CITY OF GALLUP  
CENTRAL PURCHASING OFFICE  
P.O. BOX 1270  
GALLUP, NEW MEXICO 87305-1270  
Phone: 505-863-1232; Fax: 505-722-5133  
**FOX RUN GOLF COURSE IRRIGATION PROJECT**

AMENDMENT NO.: **One (1)**

FORMAL BID NO.: **1520**

**Fox Run Golf Course Irrigation Project (Re-Bid)**

FOX RUN GOLF COURSE - GALLUP, NM
15 TEE - REBID REVISION - IRRIGATE EXISTING TEES
DATE: 12/23/2015 SCALE 1" = 100'
DRAWN BY : DON MAHAFFEY GREENSCAPE METHODS LLC PH 361.920.1439
HOWARD KAPLAN WILSON & COMPANY 4900 LANG AVENUE NE ALBUQUERQUE, NM 87109 PHONE: (505) 348-4000

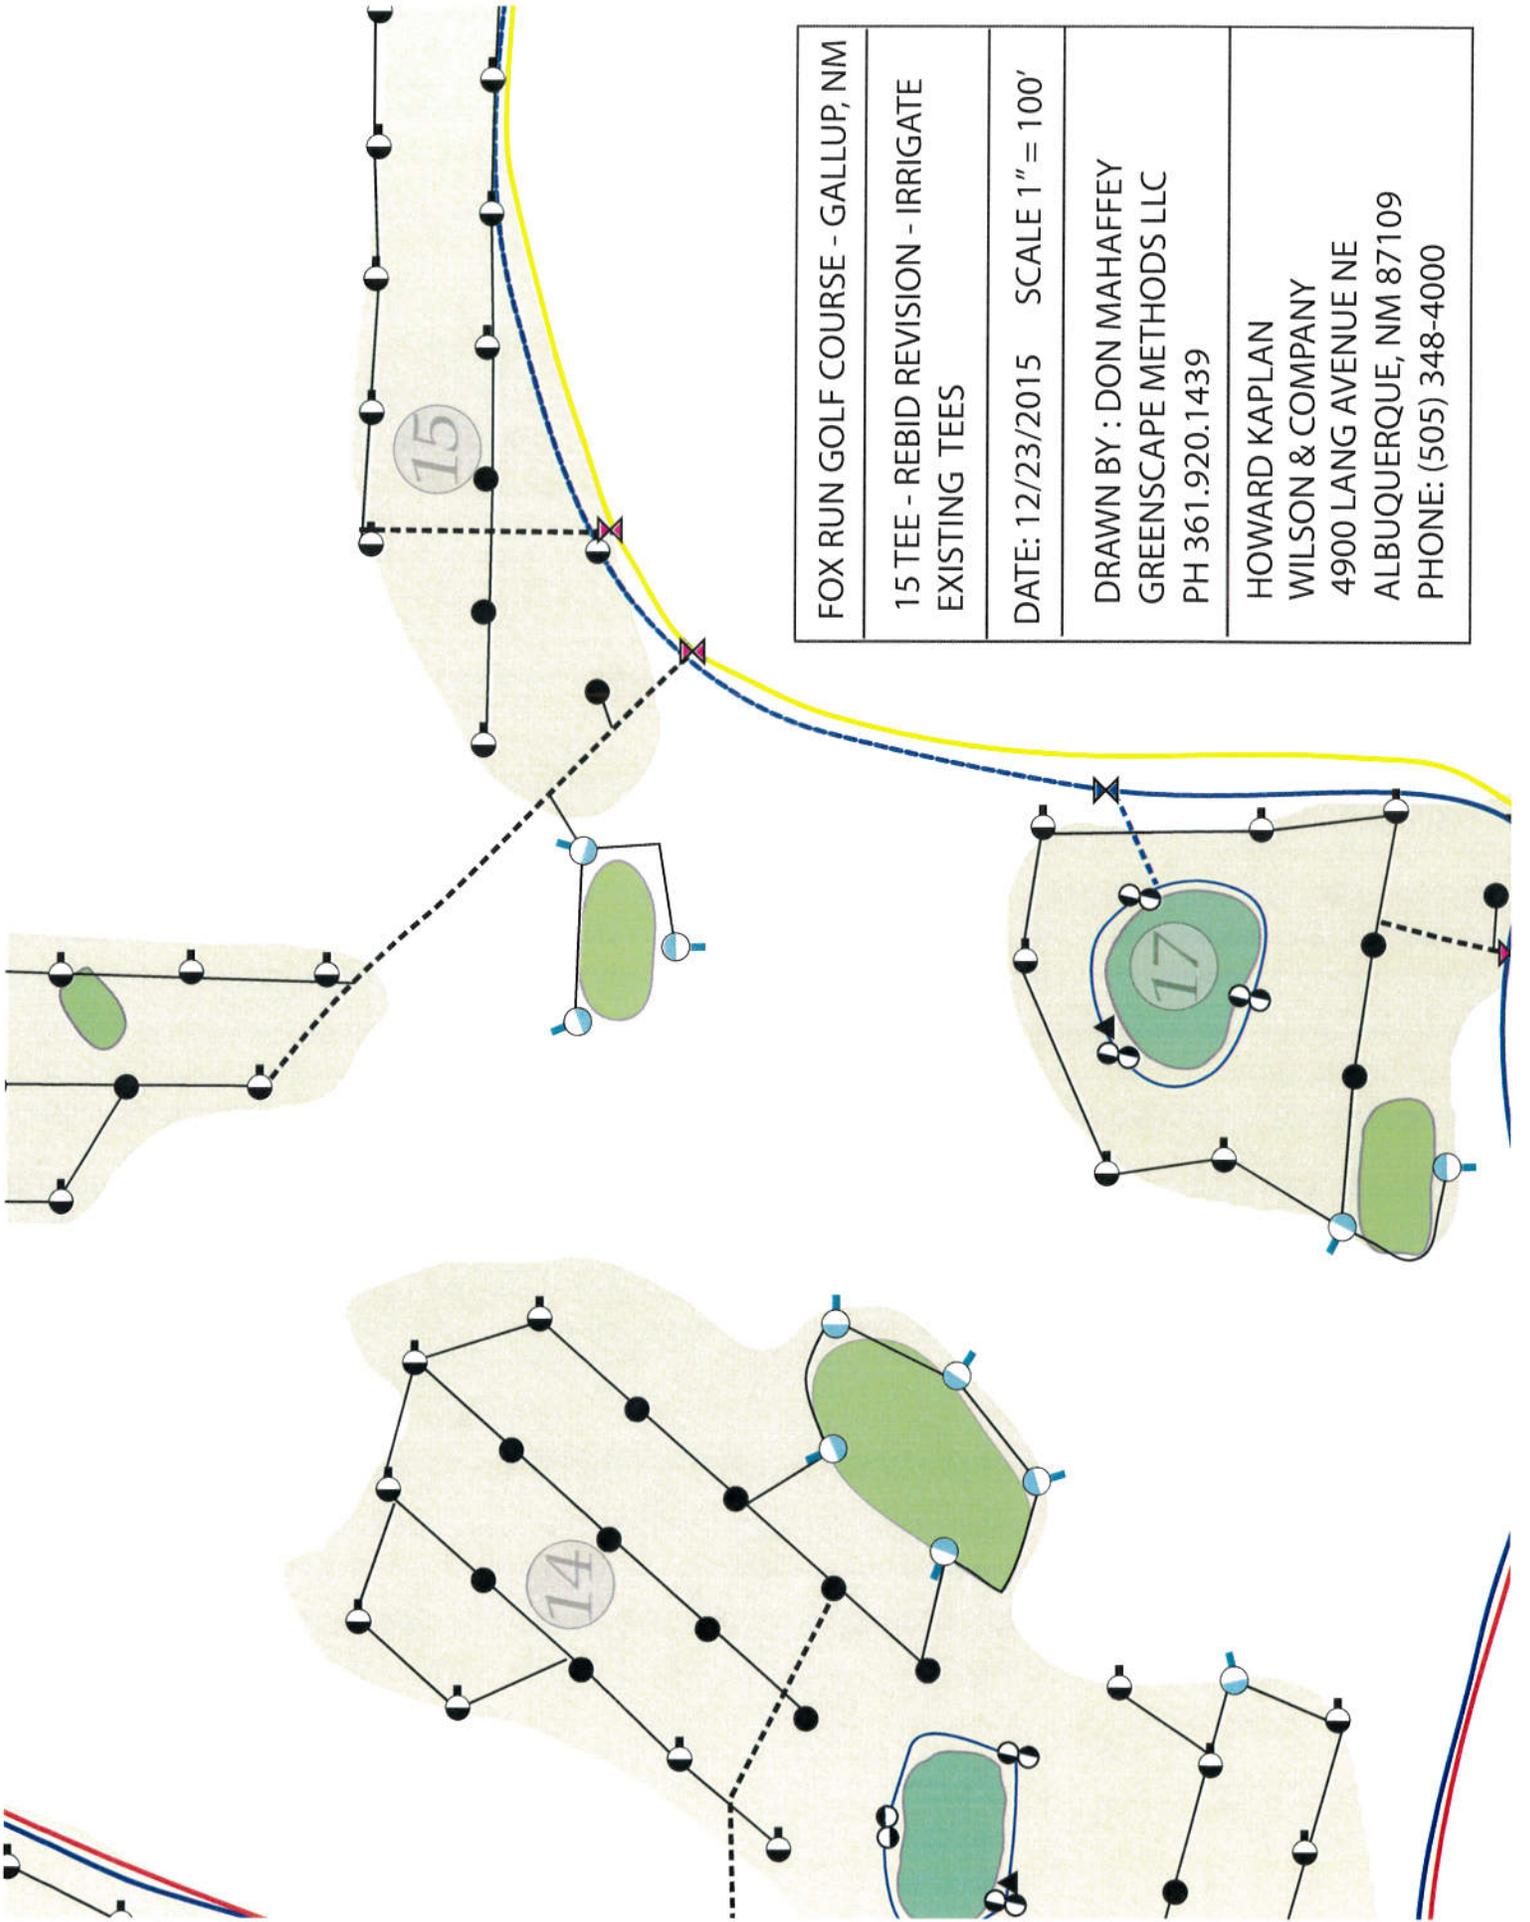
1. Sheets I-101; CG-110 and LP-107:
  - a. For Hole 15, delete reference to "New Tee" location. Existing Tee location to remain. See revised irrigation sketch attached.
2. Sheet LP-107:
  - a. Delete Additive Alternate #1, 30' HT. Ball Stop Netting.
